Re: Proposed Private Hospital, Water Street Wahroonga

We refer to the various responses to the Part 3A Application relating to the subject proposal and advise that we have reviewed the matters raised and now confirm as follows in respect of the issues arising that pertain to traffic planning matters. These are considered separately below in response to the matters raised by the RTA, the matters raised by Council, and the matters raised in public submissions.

9.0m Road Option
Car Access
1 in 400 at A4

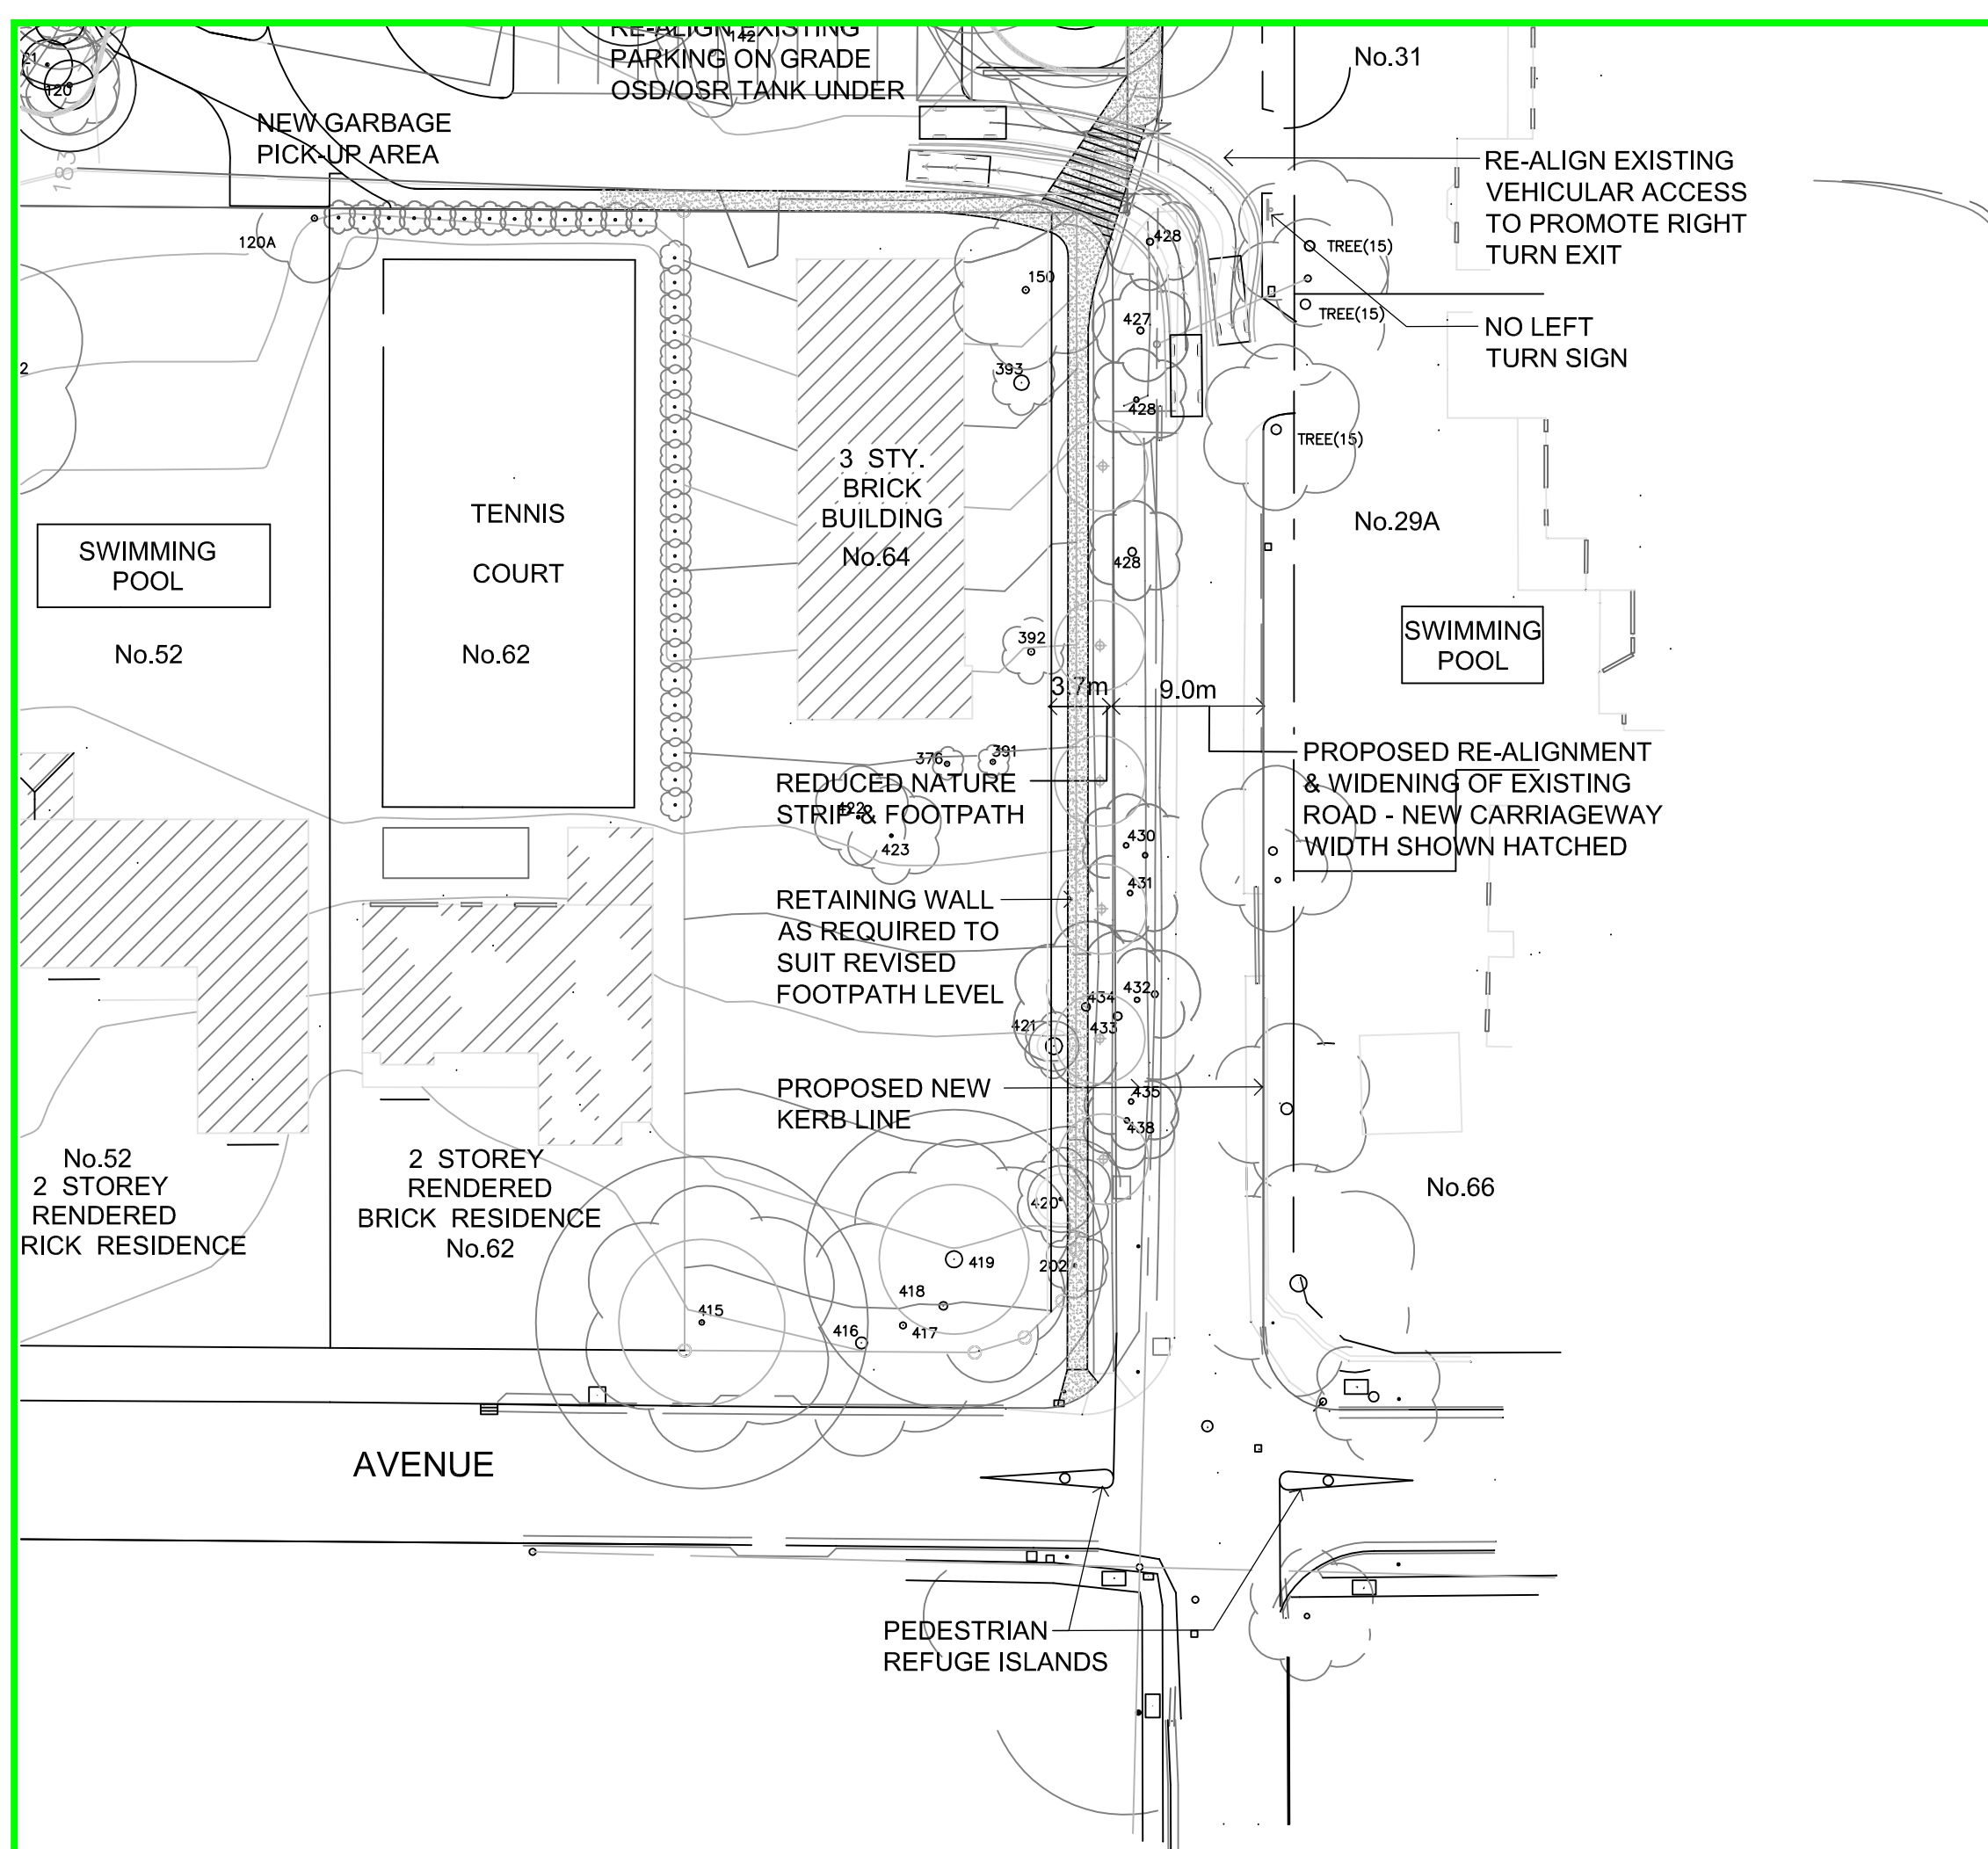
- A second option has also been prepared which accommodates a 9.0m road carriageway in Young Street between the driveway and Billyard Avenue. This is overdesigned and also has the potential to alter the character of Young Street. Nevertheless, it is able to be provided if required and will effectively enable parallel parking on the western side of Young Street over this section, for use by residents and their visitors. Reliance is not made on this parking by the proposed Hospital. The ability of a car to access the site via Young Street under this option is shown in **Attachment 3**.

- The swept paths provided in Attachments 2 and 3 demonstrate compliance using a Category 2 Driveway and no further widening is considered necessary. This width is also sufficient to accommodate occasional service vehicles. These swept paths demonstrate that the concept plans prepared for the road widening are supportable and able to be delivered. The final road designs will however presumably be the subject of a suitable condition of consent requiring that the road be constructed to Council's requirements, while the driveway will be subject to compliance with AS 2890. For reference and to assist comparison, the existing road geometry is provided in **Attachment 4**.
